**RE: Preliminary Adequacy Review; Technical Revision (TR-2); Sheep Mountain Ranch,  
Permit No. M-2017-022**

On August 27, 2021, the Division of Reclamation, Mining and Safety (Division) received a request for Technical Revision (TR-2) to update the reclamation plan map to reflect the current conditions at the Sheep Mountain Ranch site, Permit No. M-2017-022. Please be advised that on September 29, 2021, the application for TR-2 may be deemed inadequate and denied unless the following adequacy items are addressed to the Division's satisfaction. Please respond to the adequacy items with a letter summarizing each response, to the numbered items below, in a cover letter titled "Preliminary Adequacy Review Response TR-2, M-2017-022".

Attachment: TR-1 Reclamation Plan Map

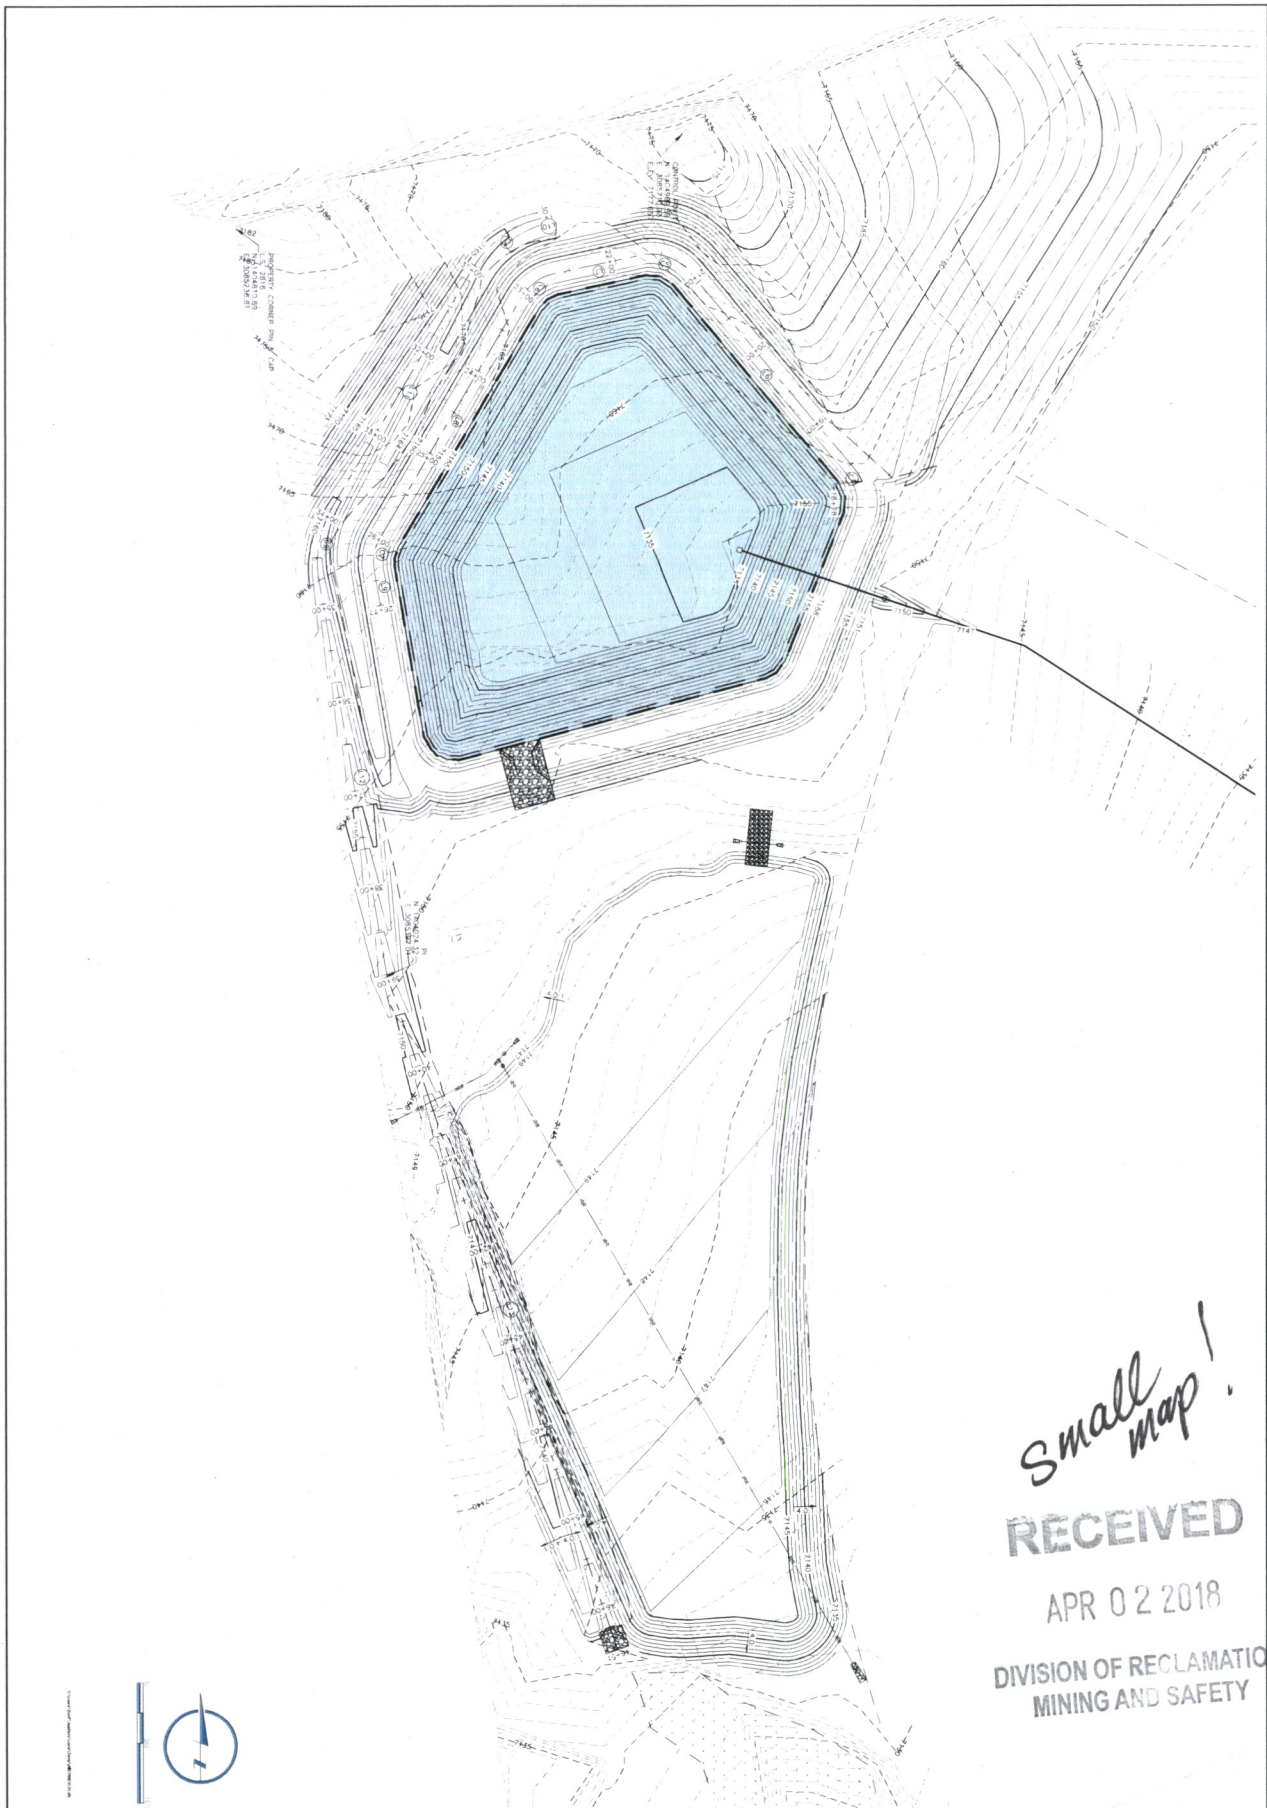
2. In April 2018 the Division approved TR-1 which allowed for extending the drainage swale along the west side of the reservoir south across the irrigation ditch, placing the ditch in a pipe under the swale, to better control runoff, see attachment. Please update the map to reflect this swale and indicate the irrigation ditch was placed in a pipe.

3. Please identify on the updated map what appears to be an overflow outlet structure near the southwest corner of the reservoir.
4. Please identify on the map what appears to be a crossing over the irrigation ditch immediately south of the end of the road leading into the facility. Also does the road end at the reservoir or does it extend to the southern area of the permit boundary connecting to the road that leaves the site? If the road does cross the permit then it needs to be shown on the map.

5. What is the structure in the southeastern corner of the permit boundary?
6. Please ensure that the map conforms to the criteria defined in Rule 6.2.1(2), specifically the map must be signed by a qualified person.
